Location of Construction: 68 Shepherd Lane		Owner: Burton, Michael		Phone: 822-7460		Permit No: <b>960444</b>	
Owner Address:		Leasee/Buyer's Name:		Phone:		BusinessName:	
Contractor Name: Goodwin, Carl		Address:		Phone:		Permit Issued: <b>ISSUED</b> <b>MAY 23 1996</b>	
Past Use: 1-fam		Proposed Use: Same w/garage		COST OF WORK: \$ 12,000.00		PERMIT FEE: \$ 80.00	
				FIRE DEPT. <input type="checkbox"/> Approved <input type="checkbox"/> Denied		INSPECTION: Use Group <i>AB</i> Type <i>5B</i> <i>BOCA93</i>	
Proposed Project Description:  Construct Attached Garage (22' x 22')				Signature:		Signature: <i>[Signature]</i>	
				PEDESTRIAN ACTIVITIES DISTRICT (P.A.D.)		Zoning Approval: <i>OK 5/22/96</i> <b>Special Zone or Reviews:</b>	
				Action: <input type="checkbox"/> Approved <input type="checkbox"/> Approved with Conditions <input type="checkbox"/> Denied		<input type="checkbox"/> Shoreland <input type="checkbox"/> Wetland <input type="checkbox"/> Flood Zone <input type="checkbox"/> Subdivision <input type="checkbox"/> Site Plan maj <input type="checkbox"/> minor <input type="checkbox"/> mm <input type="checkbox"/>

BUILDING PERMIT REPORT

DATE: 22/MAY/196 ADDRESS: 68 Shepherd Lane

FRONT ELEVATION

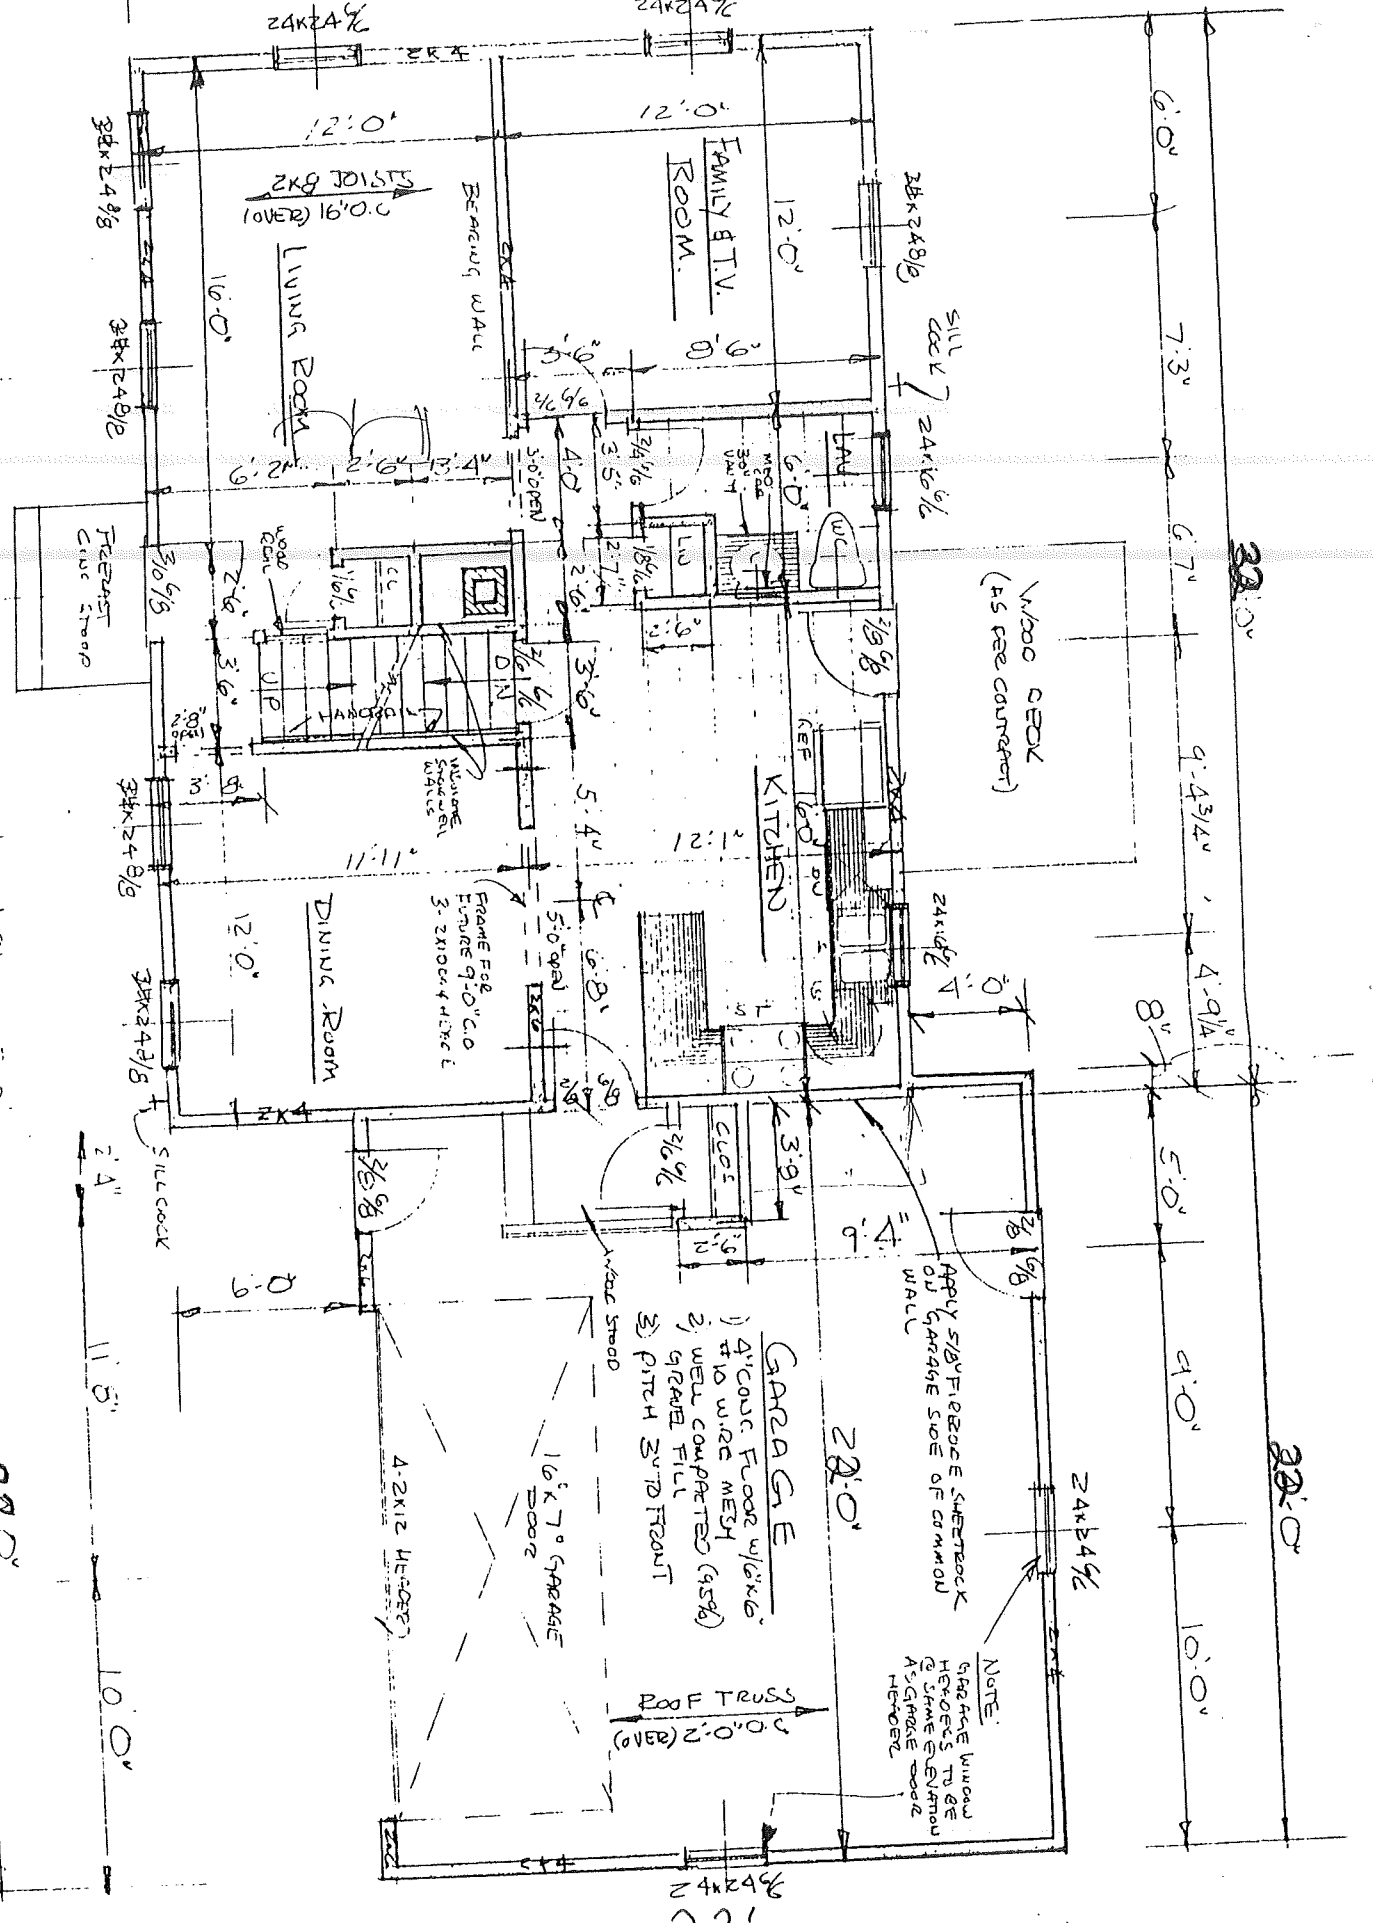
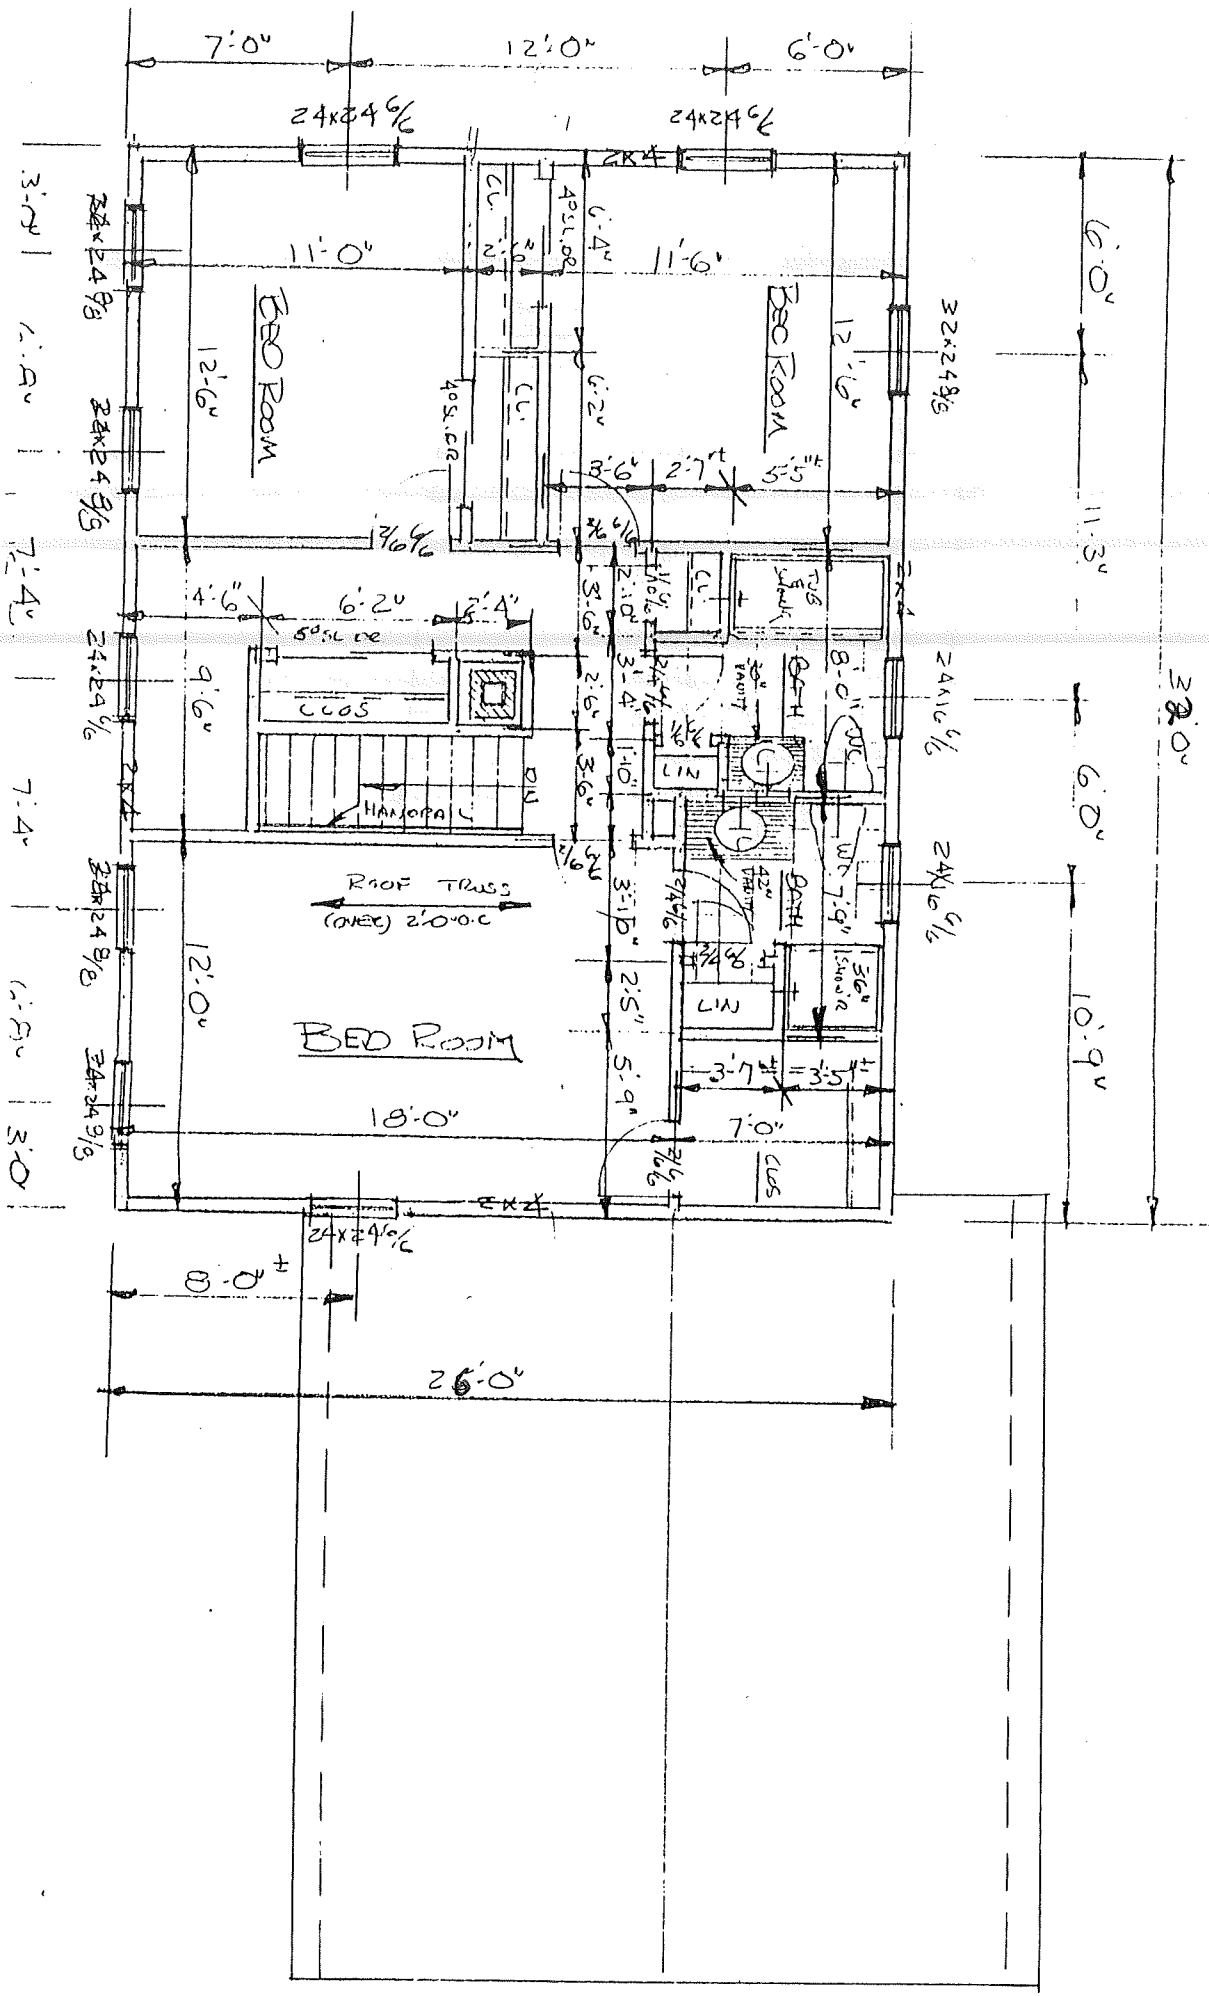
- X10. Private garages located beneath habitable rooms in occupancies in Use Group R-1, R-2, R-3 or I-1 shall be separated from adjacent interior spaces by fire partitions and floor/ceiling assembly which are constructed with not less than 1-hour fire resisting rating. Private garages attached side-by-side to rooms in the above occupancies shall be completely separated from the interior spaces and the attic area by means of 1/2 inch gypsum board or the equivalent applied to the garage side. (Chapter 4 section 407.0 of the BOCA/1993)

Apply 5/8" FIREBORE SHEETROCK ON GARAGE SIDE OF COMMON WALL

MORTGAGE INSPECTION OF: DEED BOOK 10877 PAGE 30(p/o) COUNTY Cumberland  
 PLAN BOOK 194 PAGE 112 LOT 7

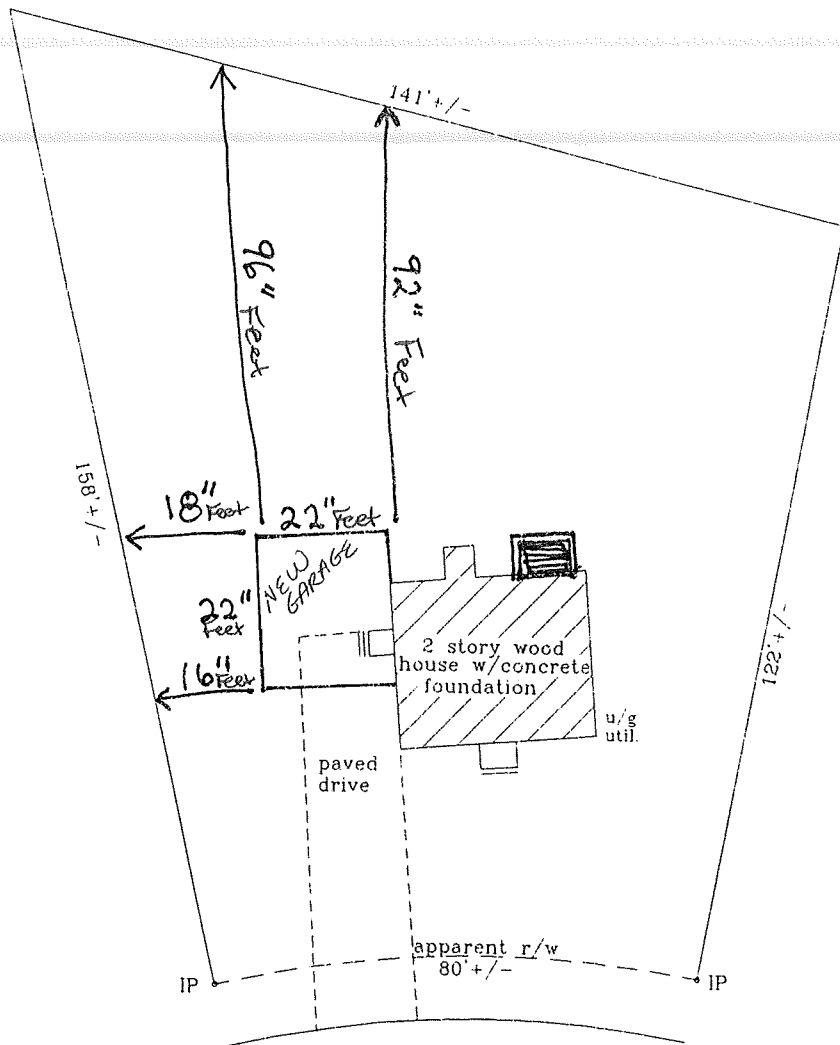
Rear Yards - 25' req. - 92' at closest

Side Yards - 8' req. - 16' at closest

Front Yards - 25' req. - OK
